Title			Spindle motor PWM filter		
Size	Number		Revision		
B					
Date:	23-Mar-2015		Sheet	of	
File:	G:\C-drive copy 24-12-14\Documents and Settings\Krypton\My Documents\Linetrek2.ddb		2	6

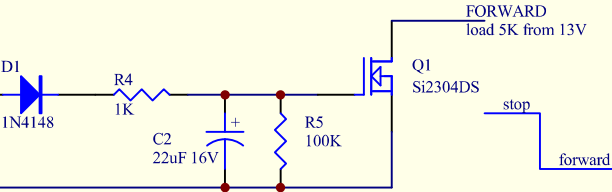
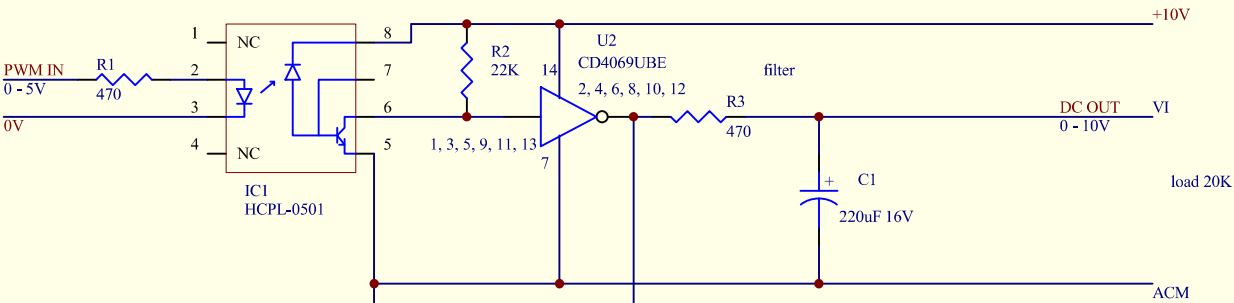
In Chris Humphris' circuit replace R4, T1 with this circuit.

extra circuit to produce forward signal only when PWM pulses are present
